P R O D U C T I O N M E M O

INSTRUMENT: 8568A SPECTRUM ANALYZER

SUBJECT: KEYBOARD SWITCH FAILURES
(FLYING SPRING SYNDROME)

Figure 1. Pushbutton Front-Panel Switch, HP P/N 5060-9436

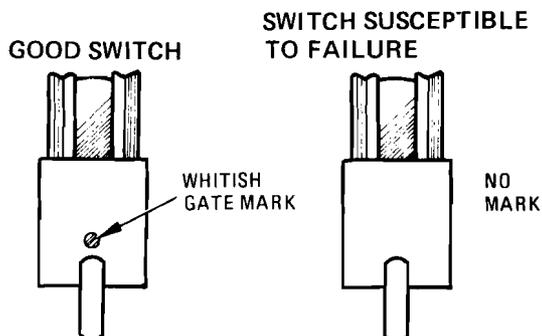
Not all switches are susceptible to the "fly-away spring" failure. Switches that have a "gate mark" (from the mold) that appears on the red body as a small whitish dot about in the center of the surface opposite the spring (see Figure 1) do not exhibit the "fly-away spring" failure.

8568A Spectrum Analyzers shipped after December 10, 1981 may have good switches that do not have a "gate mark". Therefore, the above criteria can be used to identify bad switches ONLY in 8568A Spectrum Analyzers that were shipped on or before December 10, 1981. (Serial Numbers 2118A01500 through 2140A01700 for the 85680A; 2112A02340 through 2134A02750 for the 85662A.)

Rebuilt (Blue-Stripe) keyboards have been set up for the RF Section and IF-Display Section; 85680-60141 and 85662-60129 respectively. The rebuilt keyboards include all key caps and all front-panel LEDs. For 85680A RF Sections with serial numbers 2118A01500 through 2140A01700, and 85662A IF-Display Sections with serial numbers 2112A02340 through 2134A02750, follow **PROCEDURE** in this Production Memo. For instruments that do not fall within the above designated serial number ranges, but appear to exhibit the "fly-away spring" failure, contact the 8568A Product Support Engineer before beginning repair.

DO NOT REPLACE KEYBOARDS UNLESS AT LEAST ONE SWITCH HAS FAILED and the failure mode is a "fly-away spring". If one or more switches have failed in this manner, replace both the RF Section Keyboard and the IF-Display Section Keyboard.
